Product Change Notification / JAON-06SLTO183

CCB 4634 Final Notice: Qualification of MMT as a new assembly site for selected Atmel AT28HC256, AT28C256 and AT28BV256 device families available in 32L PLCC (11.5x14x3.37mm) package.

Pre and Post Change Summary

PCN # JAON-06SLTO183

Lead frame Comparison

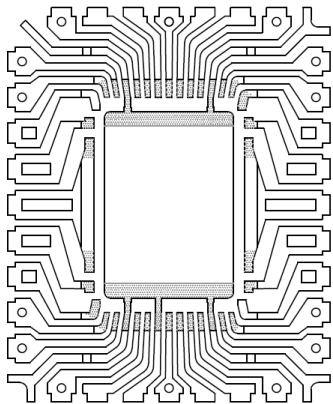
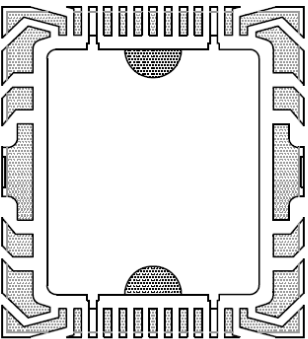
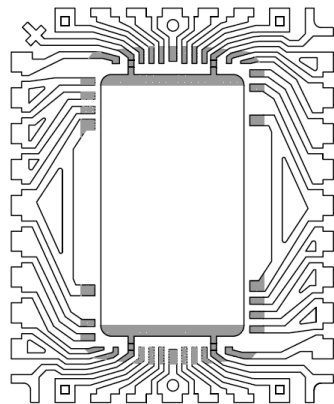
Pre Change		Post Change
LPI		MMT
 <p>PAD SIZE:181x261 MILS FUSED LEAD ON PIN#16</p>	 <p>PAD SIZE:225x260 MILS NON-FUSED LEAD ON PIN#16</p>	 <p>PAD SIZE:200x365 MILS NON-FUSED LEAD ON PIN#16</p>
